**Proposal for amendments to ECE/TRANS/WP.29/GRVA/2019/17
Proposal for amendments to false reaction avoidance of UN
Regulation 152 from the IWG on AEBS**

5.1.6. False reaction avoidance

False Reaction scenarios

2. Pedestrian Target

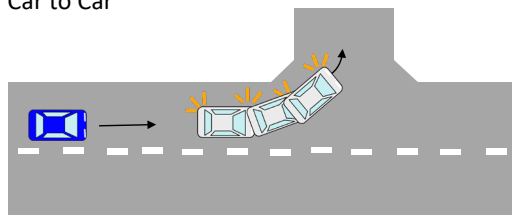
- 2.1. A pedestrian target as prescribed in 6.3.2. shall be positioned:
- So as to face in the same direction of travel as the subject vehicle.
 - With a distance of 1 m **(with a tolerance of +0.2/-0.0 m)** from the subject vehicle side closest to the target toward the side in the direction of traffic.
- 2.2. The subject vehicle shall travel in a straight line for a distance of at least 60 m. at a constant speed in the range of speeds listed in the Table of paragraph 5.2.2.4. to pass the stationary pedestrian target.
- During the test there shall be no adjustment of any subject vehicle control other than slight steering adjustments to counteract any drifting.
- 2.3. The AEBS **[shall not provide a collision warning and]** shall not initiate the emergency braking.}

Car to Car

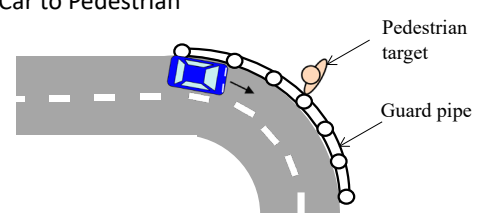
- The test vehicle is running on a straight road, and approaches a frontal vehicle which is turning left at low speed.
